EAGLE MOUNTAIN PLANNING COMMISSION MEETING

March 9, 2021, 5:30 PM

TITLE:	PUBLIC HEARING - O'Reilly Auto Parts (Site Plan)
ITEM TYPE:	Site Plan
APPLICANT:	Creed Richardson (Leading Tech Development)

1 FRONT EXTERIOR ELEVATION

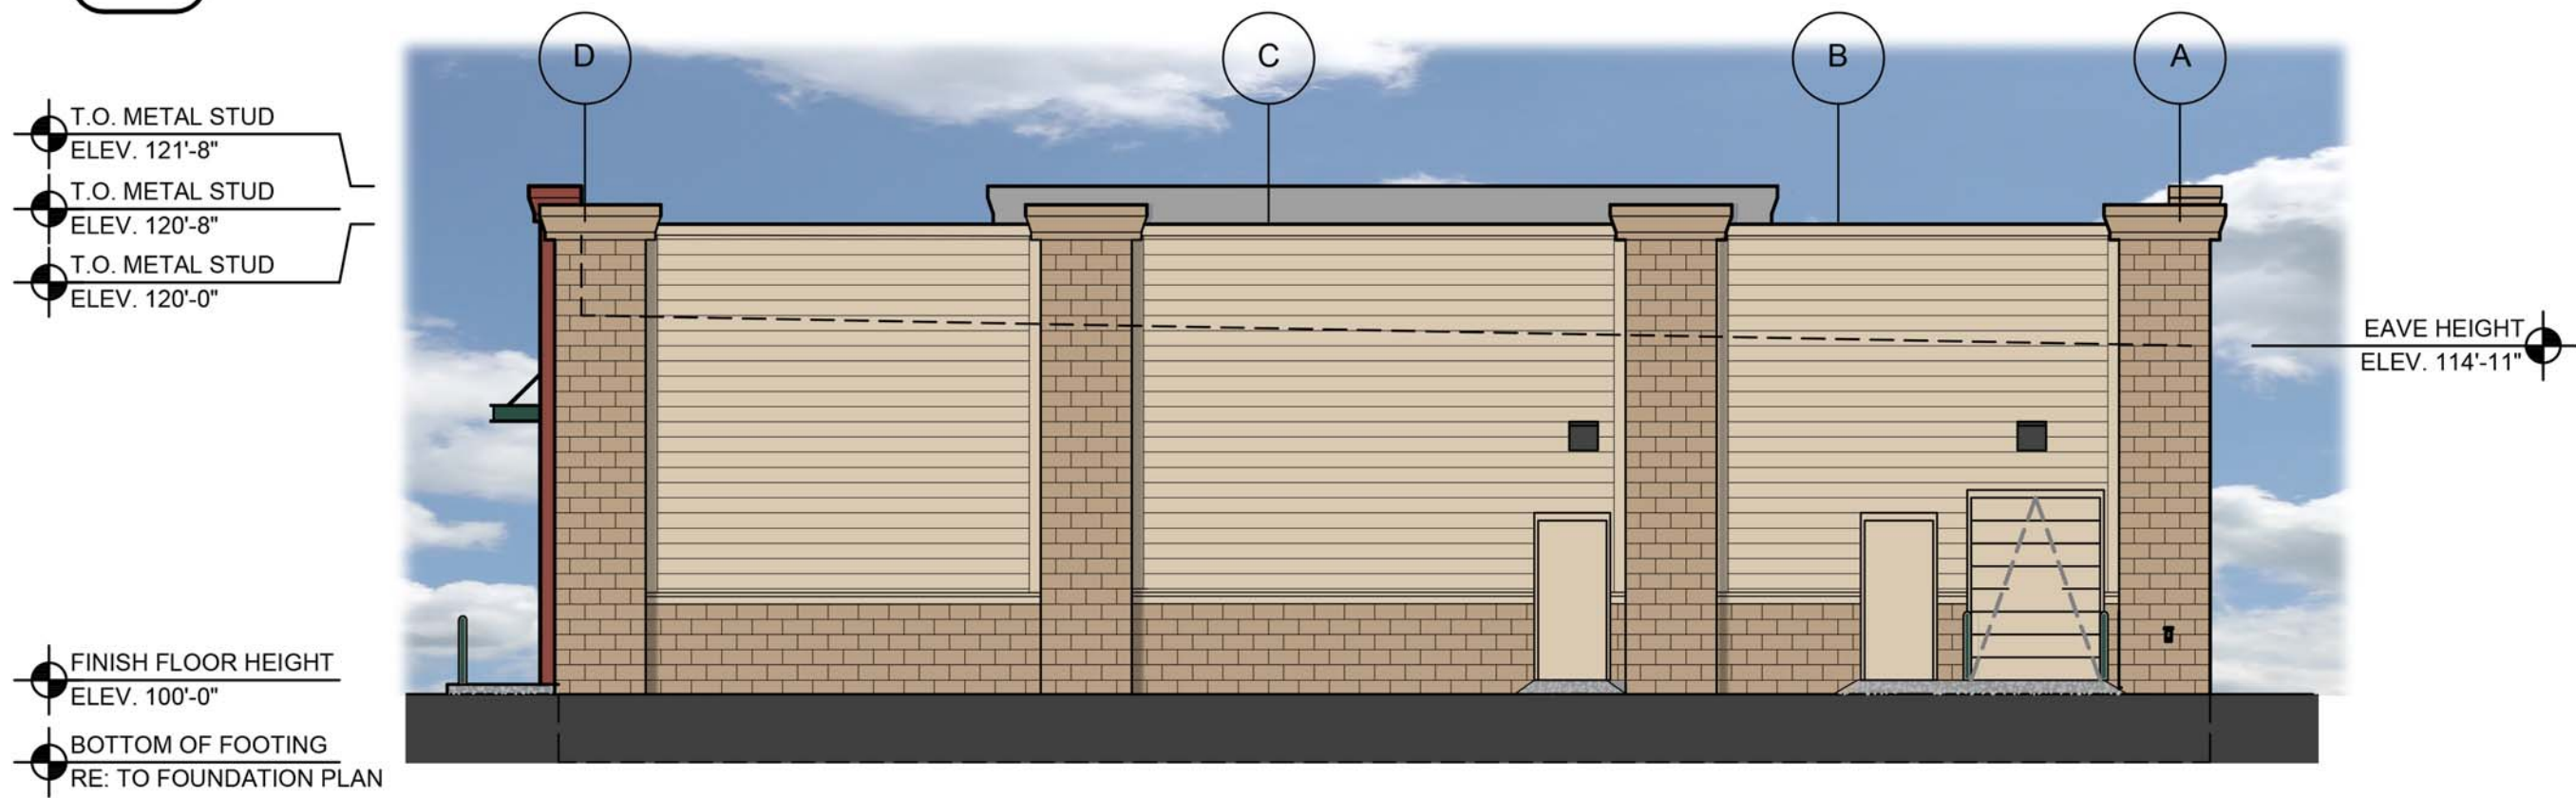
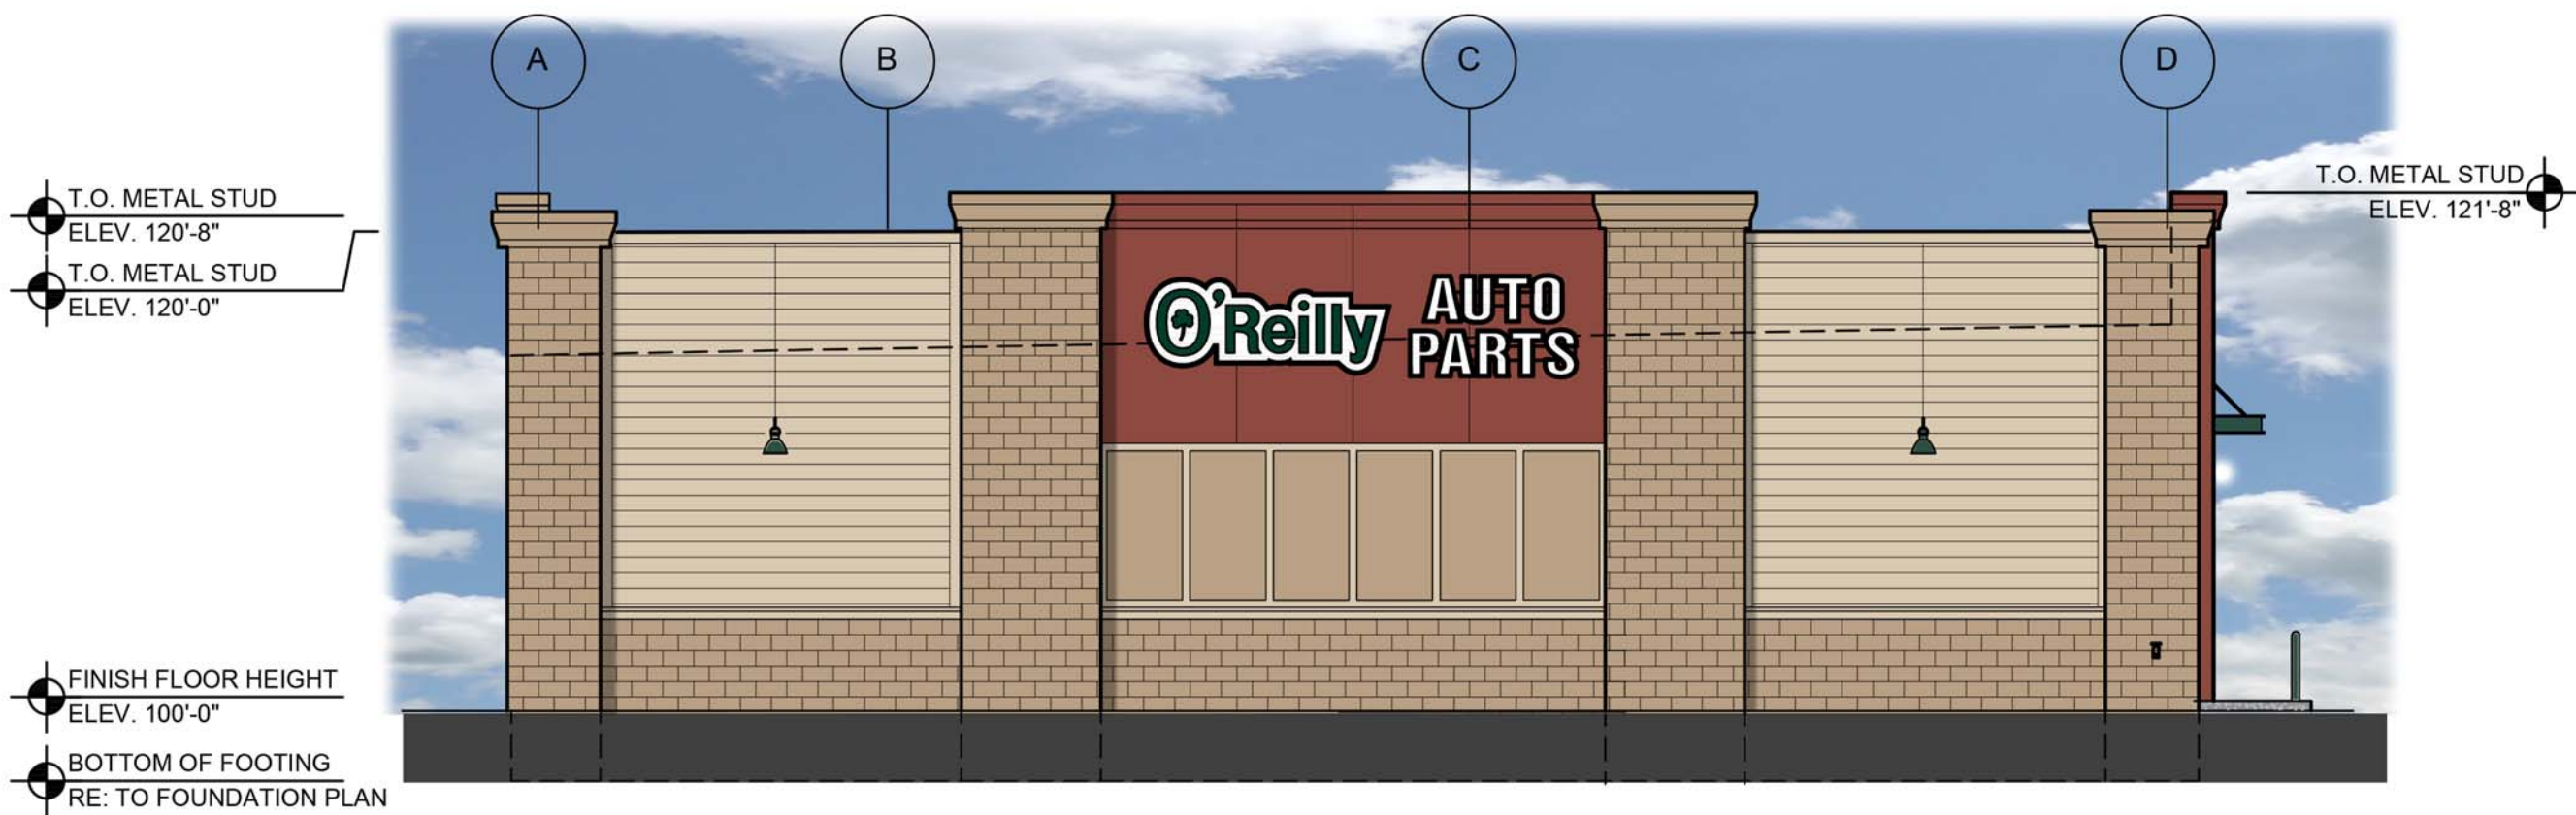
Per EMMC 17.72.030 A.1, the primary entrance to the building should orient toward the street, and if not the street-facing façade should include entrances, display windows, awnings, increased architectural elements, increased landscaping, and other pedestrian-oriented features. The street-facing façade (North Elevation) does not include the primary entrance to the building. While it does feature windows, an awning and a sidewalk path are provided from the trail along Pony Express Parkway to the main entry (West Elevation incorrectly labeled "East Elevation") it is up to the Planning Commission to determine if there are enough architectural elements to comply with this provision. (Attachment #2 – Elevations)

EMMC 17.72.040 C states "The primary roof form of a structure should help reduce the perceived scale of the building. All commercial buildings shall contain either sloping roofs with overhanging eaves or a decorative parapet and multiple roof planes and heights. Decorative cornices and roof projections such as cupolas

or towers are also encouraged.” The proposed elevations do not include sloping roofs, nor do they include decorative parapet, and only very minor changes in rooflines. It is the opinion of staff that elevations should be amended to include a tower or to increase the height of the parapet above the main entry and columns to give the appearance of different roof planes and heights. (Attachment #2 – Elevations)

2. Elevations shall be updated to include stacked stone and materials similar in color to Dollar Tree and Eagle Vision
3. Elevations shall be amended to include a tower or to increase the height of the parapet above the main entry and columns to give the appearance of different roof planes and heights.

4. At least three (3) additional design elements designated in EMMC 17.72.040 E.1 are added to all four elevations.
5. The primary color of the building shall be similar to that used on Eagle Vision and Dollar Tree.
